INITIAL FIRE SAFETY INSPECTION REPORT

Adury Apparels Ltd. (Extension 2)

RSC ID: 24735

Date: 09 November, 2023

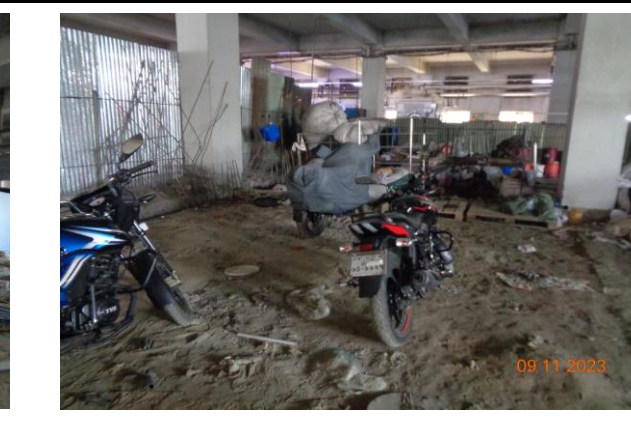
F-5	Fire Rated Construction	The exit court serving stair-03 (East stair) is less than 10 ft wide & not protected from opening on exterior wall.	Egress courts less than 3050 mm (10 ft) in width (as measured from Building-01 to Building-02) shall be provided with walls having a 1-hr fire resistance rated construction materials for a distance of 3050 mm (10 ft) above the floor of the court.	Within 3 months
